**ADDENDUM No. 1
TOWN OF MEDLEY**

DATE: April 8, 2014
PROJECT NAME: NW 121st Way Water Distribution System Loop
BID No.: 2014-001
BID OPENING DATE: Tuesday April 15, 2014

**NW 121st WAY
WATER
DISTRIBUTION
SYSTEM LOOP**

**SHEET:
WATER LOOP
PLAN AND
PROFILE**

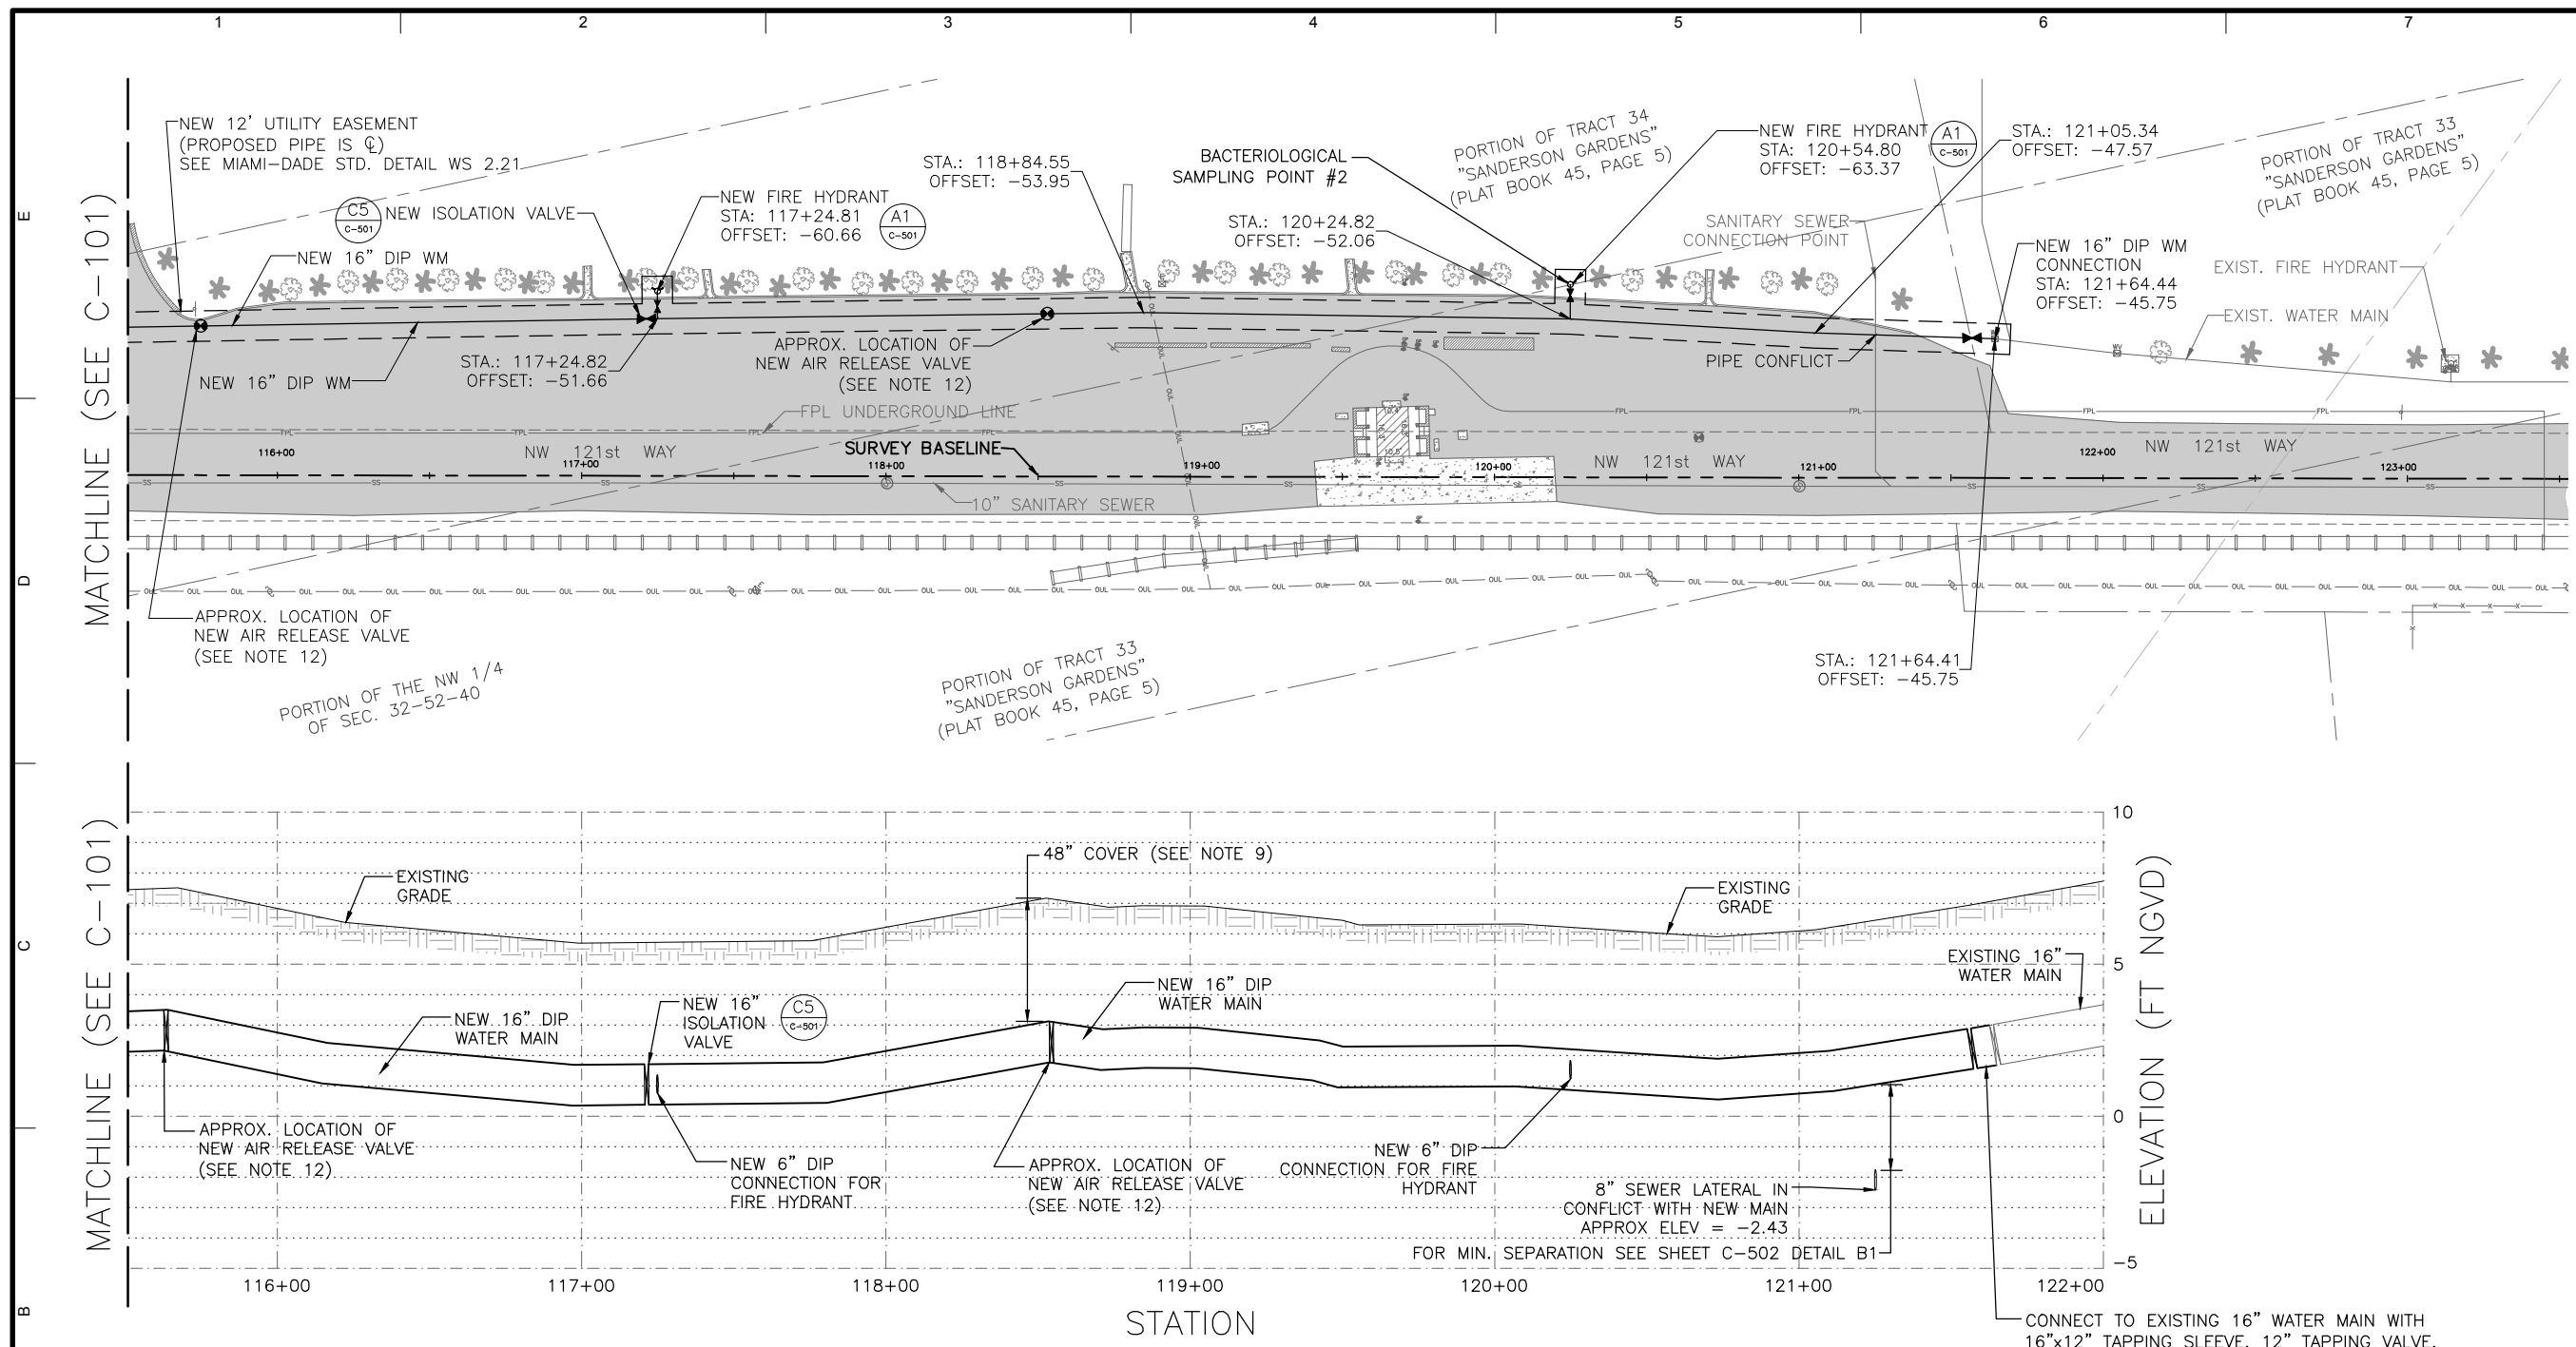
At approximately Station 115+75 on NW 121st Way, the Contractor shall install a new air release valve along the proposed 16" main that is not properly depicted on the drawings previously provided. Please replace Sheet C-102 (7 of 11), Water Loop Plan and Profile of the bid drawings with the revised Sheet C-102 attached to this Addendum No. 1.

- CONTRACTOR TO VERIFY THE LOCATION AND TYPE OF EXISTING UTILITIES IMPACTED BY THE PROJECT PRIOR TO CONSTRUCTION.
- INSTALL AIR RELEASE VALVE AT LOCAL HIGH POINT ALONG NEW WATER MAIN. FOR TYPICAL AIR RELEASE VALVE INSTALLATION, SEE MIAMI-DADE COUNTY STANDARD DETAIL WS 1.60.
